User Manual Errata
MC68307 Integrated Multiple Bus Processor

Date: Tues, 25th July 1995.

Figure 3-12. 8051-Compatible Read Cycle Signals

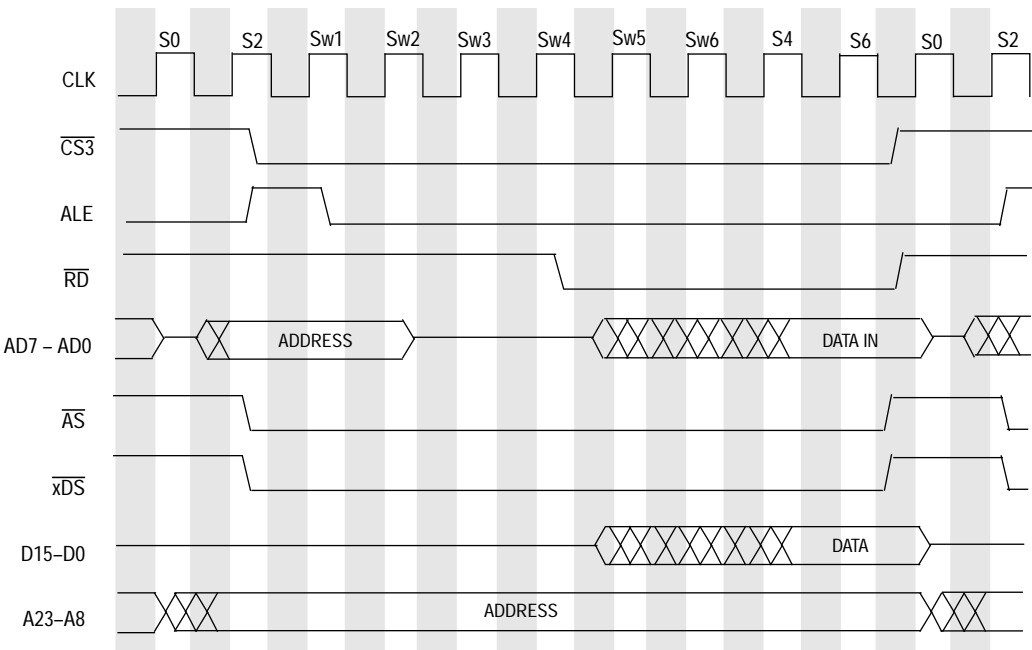
p3-14: Section 3.1.7., 8051-Bus Operation. The 8051-compatible read and write cycles should be as follows:

11-13. Port Timing

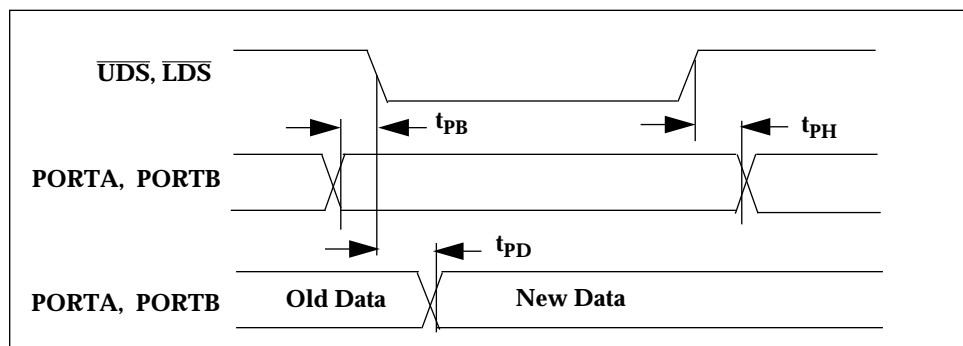
p11-16: Section 11.14, AC Electrical Characteristics - Port Timing. The 8MHz and 16.67MHz timing values should be changed and the tPD time referenced to UDS/LDS assertion as follows:

Characteristic	Symbol	3.3V		3.3 V or 5 V		Unit
		8.33 MHz		16.67 MHz		
		Min	Max	Min	Max	
Port Input Setup Time to $\overline{\text{UDS}}$, $\overline{\text{LDS}}$ Asserted	tPS	0	—	0	—	ns
Port Input Hold Time from $\overline{\text{UDS}}$, $\overline{\text{LDS}}$ Negated	tPH	0	—	0	—	ns
Port Output Valid from $\overline{\text{UDS}}$, $\overline{\text{LDS}}$ Asserted	tPD	—	20	—	10	ns
